TECHNICAL MEMORANDUM

Project No.: 093-81962

**RE: ROSEMONT COPPER PROJECT
REVIEW OF "ROSEMONT SITE WATER MANAGEMENT UPDATE REVIEW RESPONSES"**

RE: ROSEMONT COPPER PROJECT, TECHNICAL REVIEW OF SITE WATER MANAGEMENT UPDATE

FIGURE 2
DETAIL OF THE FLOW-THROUGH INLET

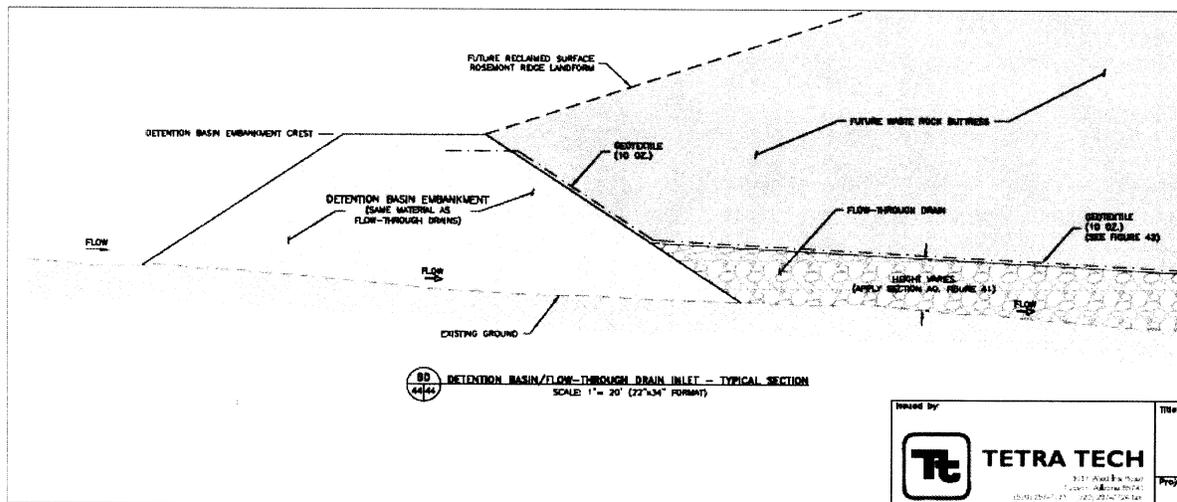
Golder was requested to specifically comment on the entrance arrangement to the flow-through drains, shown in Figure 2. It is our opinion that sediment from upstream will likely clog the berm over the medium to long term. This is due to the fact that no upstream provision is made to prevent sediment from entering the berm.
